Service Bulletin

Subject: Lamp Adjust Spring

Product Line: Studio Command

Date: 10/06/06

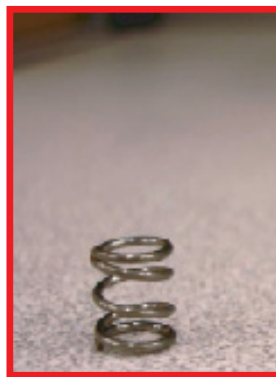
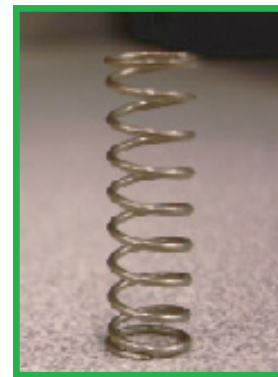
A limited number of fixtures were manufactured using adjustment springs that were too short, causing the optimizing plate to be in the wrong location, and making it impossible to properly optimize the lamp output.

The wrong spring has four (4) winds to its coil.

Wrong
(Four wind Coil)

The correct spring has nine (9) winds to its coil.

Correct
(Nine wind Coil)

Lamp Adjust Assembly

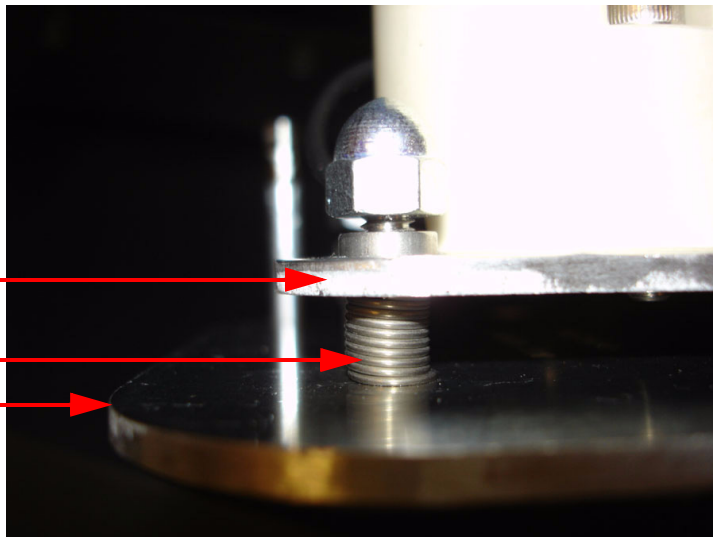
The Studio Command lamp adjust assembly utilizes three (3) springs for adjustment between the "Outer Access Plate" and the "Lamp Socket Plate."

Nine (9) Wind Spring
